ECE/TRANS/WP.29/2007/66
16 July 2007

Proposal for Supplement 4 to the 03 series of amendments to Regulation No. 48

(Installation of lights and light-signalling devices)

Submitted by the Working Party on Lighting and Light-signalling

Indication of the downward inclination of the front fog lamp cut-off referred to in paragraph 6.3.6.1.2. of this regulation

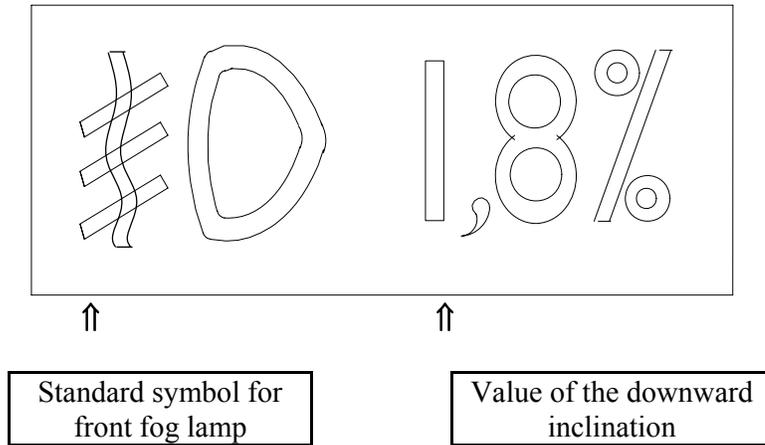
Annex 7, amend to read:

"Annex 7

Example 1

The size of the symbol and characters is left to the discretion of the manufacturer.
